LA 45 COMPO: Headlight Mount Rework

Property name and top bus number: LA 45CLFW 218000, 269000

Issue: Headlight bulb doesn't fit the mounting bracket (bucket) correctly.

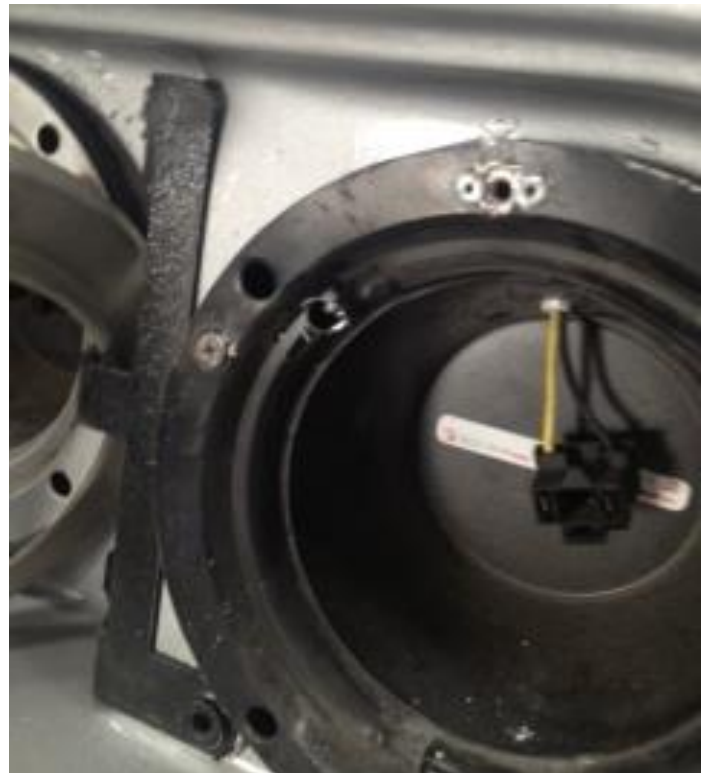
5. Inspect the headlight mounting bracket (bucket) and replace as required. If bracket is in good condition (threads, tabs, etc.) then place and position the template to the mounting bracket as picture shows below.

6. Drill a pilot hole by using a 1/8" drill bit through the required hole: #1 mark is for low beam bulb and #2 mark is for high beam bulb.

7. Enlarge the hole by using a 5/16" drill bit.
